# Rezoning Transportation Analysis

Petition Number: 2025-027

Date	Description
05-28-25	First Review (IW)
07-23-25	Second Review (IW)
08-26-25	Third Review (IW)
09-23-25	Fourth Review (IW) ZC
01-22-26	Fifth Review (IW)
02-19-26	Sixth Review (IW)
03-20-26	Seventh Review (IW)

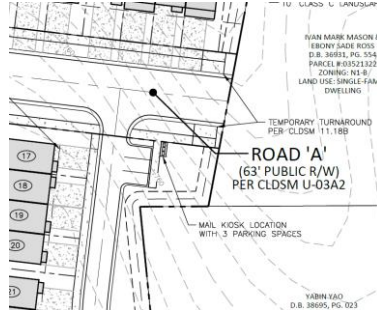
3. ~~Add a conditional note specifying "A Right of Way Encroachment Agreement is required for the installation of any non-standard item(s) (irrigation systems, decorative concrete pavement, brick pavers, etc.) within a proposed/existing City-maintained street right-of-way by a private individual, group, business, or homeowner's/business association. An encroachment agreement must be approved by CDOT prior to construction/installation. Contact CDOT for additional information concerning cost, submittal, and liability insurance coverage requirements."~~

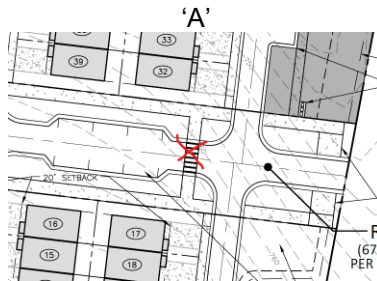
- ~~7. Add a conditional note specifying “the Petitioner shall dedicate and convey in fee simple all rights-of-way to the City before the site’s first building certificate of occupancy is issued. CDOT requests rights-of-way set at 2’ behind back of sidewalk where feasible.”~~
- ~~8. Add a conditional note specifying “All transportation improvements will be approved and constructed before the site’s first building certificate of occupancy is issued.”~~

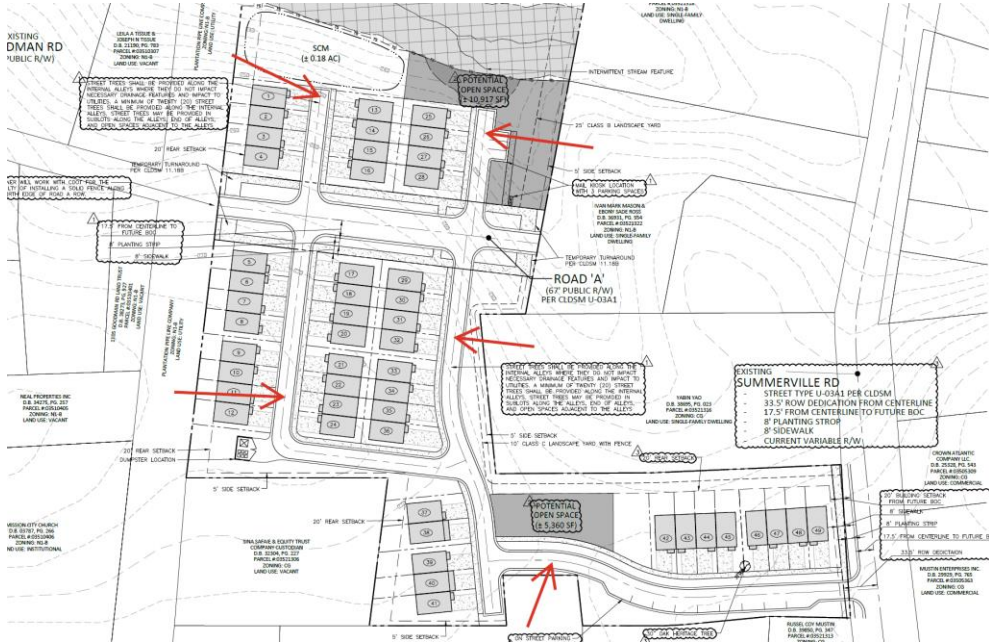
- ~~10. **Comment Rescinded 03/20/26: OUTSTANDING COMMENT BASED ON UPDATED SITE PLAN 01/22/26:** Revise site plan and conditional note to connect proposed ROW by extending “Road A” to existing Goodman Road as stated in “Part X. Subdivision Streets Other Infrastructure” in the UDO.~~

~~**Clarifying Comment 02/19/26: Ensure all coordination with subdivision is finalized regarding roadway connection.**~~

**CDOT received direction from Planning-Subdivision that the existing road does not meet the definition for “Public Road” therefore not triggering the requirement for the road extension.**

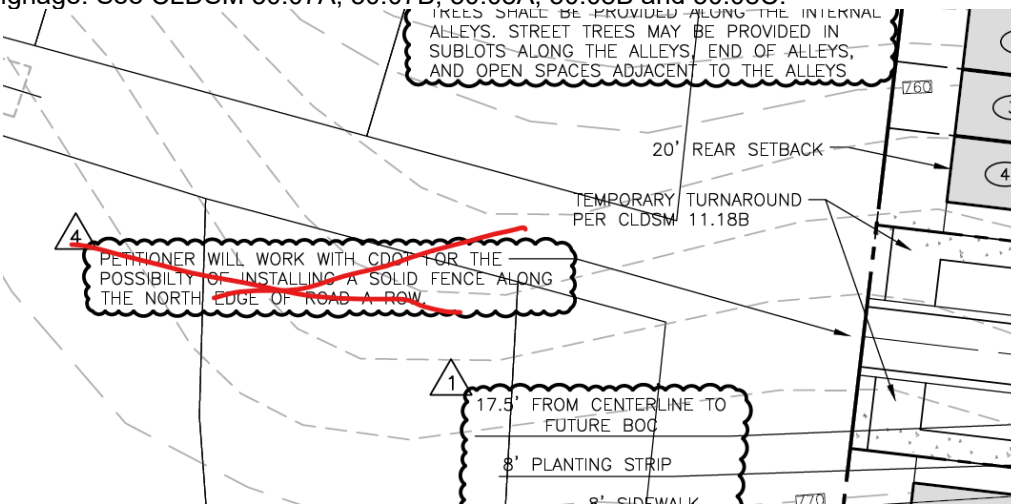
11. **OUTSTANDING COMMENT FROM 02/19/26:** Revise site plan and conditional note to clearly label internal access road (non network required roadway) connecting proposed road A and Summerville Road as a private alley or private roadway. Add a conditional note identifying each.
